October 2, 2009

Project Name:	The Bay House	Project ID:	09-99600006
Address:	113 Newbury Street	CBL:	020-D-032-001
Applicant:	Village at Oceangate, LLC		
Planner:	Barbara Barhydt, Development Review Services Manager

On September 22, 2009 the Portland Planning Board considered the Bay House for 82 residential units, commercial space, and two levels of parking with 159 spaces. The Planning Board reviewed the proposal for conformance with the standards of the Subdivision Ordinance and Site Plan Ordinance. The Planning Board voted unanimously (4-0, Lewis, Lowry, and Tevanian absent) to approve the application with the following motion(s), waivers, and condition(s) as presented below.

UTILITY PLAN
 OF: **THE BAY HOUSE**
 112 NEWBURY ST., 113 NEWBURY ST., 40 HANCOCK ST.
 PORTLAND, MAINE
 FOR: **THE VILLAGE AT OCEAN GATE, LLC**
 133 PEARL STREET, SUITE 400
 BOSTON, MA 02110
 DATE: 8/3/05 SCALE: 1" = 30'
SHEET 7 OF 15

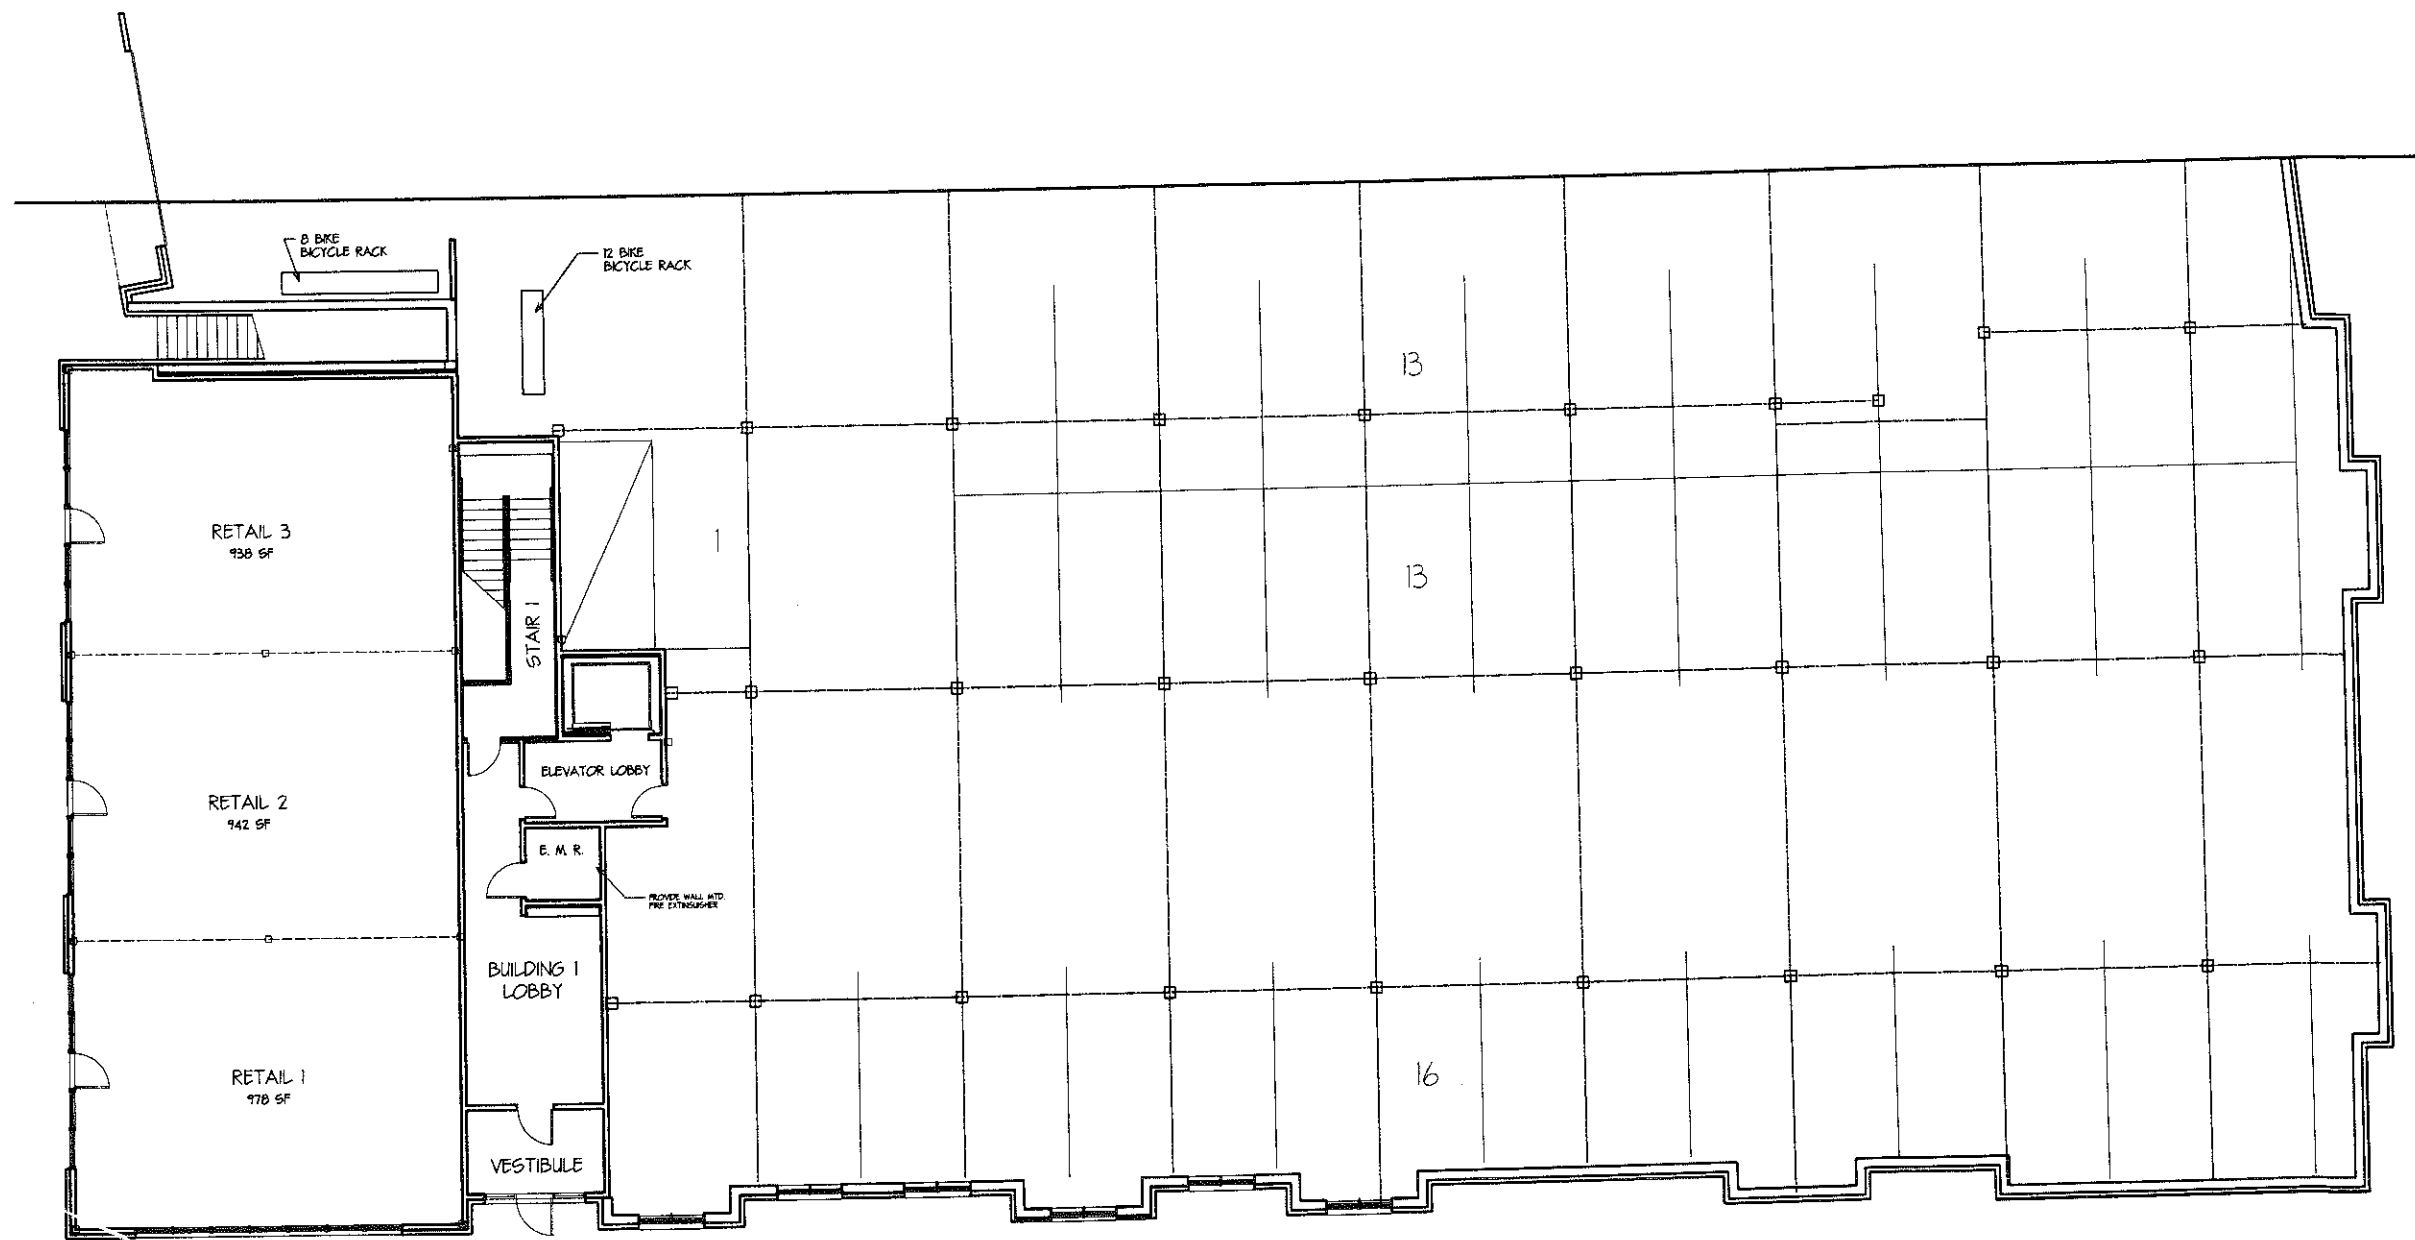
1. The grease trap detail, on page 13, is still incomplete. It is still missing a third (middle) port, for inspection and maintenance.
2. The grease trap, shown on sheet 7) is still not out of the City's street R.O.W. Move it out, please.
3. The volume of process waste is still unknown. The 1000 gallon

grease trap, as shown on sheet 7, limits the average daily process flow to 667 gallons.

4. The storm drain structure schedule (sheet 7) regarding a missing invert into DMH-4 is okay.
